Re : Product safety notice – Orion Alpha Hydraulic Power Units / High pressure Circuit

SAFETY NOTICE

This safety notice is applicable to Bucher Hydraulics Orion Alpha UD-470/600 hydraulic power units.

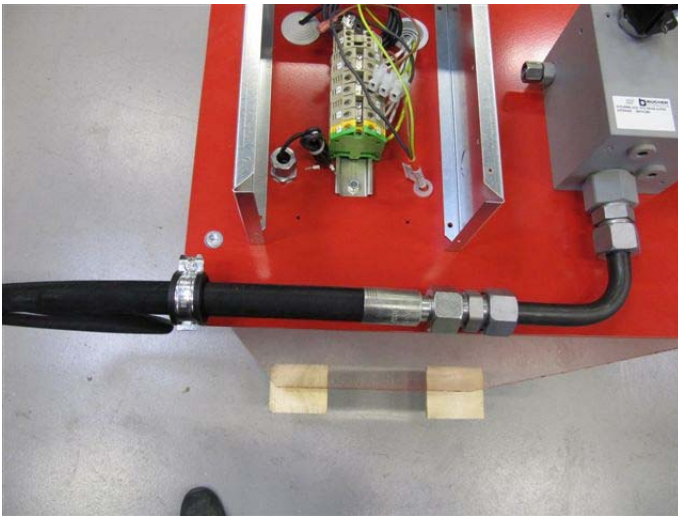
A failure occurred within the high pressure hydraulic circuit between accumulators and accumulator valve. A high pressure fitting at one end of the swept bend connecting valve to hose became detached. The high pressure hose disengaged spraying oil around the motor room.

We have identified the probable cause of the fitting failure as being the incorrect placement and press fit of the "olive" at one end of the pressure pipe bend during manufacturing.

The incident was exacerbated by the hose not being correctly clamped as recommended (every 1.5m between power unit and accumulators) The loose hose was therefore able to "thrash about" within a considerable radius, thereby causing additional damage.

1. The pipe bend should be fitted as shown above, with the long end pointing towards the back of the power unit. Bucher Hydraulics have provided a clamping fixture on the tank, as shown above, which is now standard on all new units, and is also available as a retrofit item.

2. Most importantly, and irrespective of the availability of a clamping fixture on the tank, the high pressure hose must be clamped (as is required by good hydraulics practice anyway) securely to a wall and or other fixture every 1.5m between power unit and accumulators. Bucher Hydraulics provide the required clamps with every delivery. These clamps are of course also available as retrofit items if they were not fitted or have been mislaid in the interim.
